# UNITED STATES PATENT AND TRADEMARK OFFICE

10/825,769

<b>Office Action Summary</b>	<b>Application No.</b> 10/825,769	<b>Applicant(s)</b> ANTHONY ET AL.	
	<b>Examiner</b> VICTOR MACARTHUR	<b>Art Unit</b> 3679

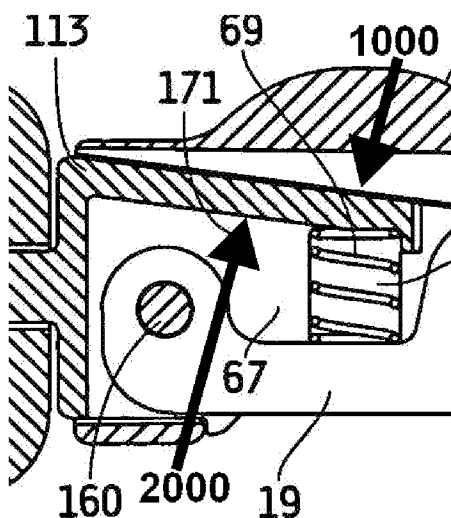
Claims 61-76 are rejected under 35 U.S.C. 112, first paragraph, as containing subject matter which was not described in the specification in such a way as to reasonably convey to one skilled in the relevant art that the inventor(s), at the time the application was filed, had possession of the claimed invention. The claims recite “the biasing member extending between the top surface of the frame and the lever” (last three lines of claim 61). Applicant has not pointed out where the amended claim is supported, nor does there appear to be a written description of the claim limitations in the application as filed such that this newly added limitation constitutes new matter. That is to say that the above limitations are not recited in the application as originally filed. Note that even the present application fails to provide antecedent basis for the terms in the written description. See marked-up version of applicants figure 8A below which clearly shows that applicant’s originally presented biasing member (69) does not contact the top surface (1000) of the frame (113) much less extend therefrom. Rather, the originally presented biasing member (68) extends between an inner surface (2000) of the frame and the lever.

Claim 61 would be allowable if rewritten to overcome the rejection(s) under 35 U.S.C. 112, 1st paragraph, set forth in this Office action and to include all of the limitations of claims 63, 64 and 76. Note that applicant should be careful to avoid unclear lack of antecedent basis and/or double inclusion problems when constructing such a claim.
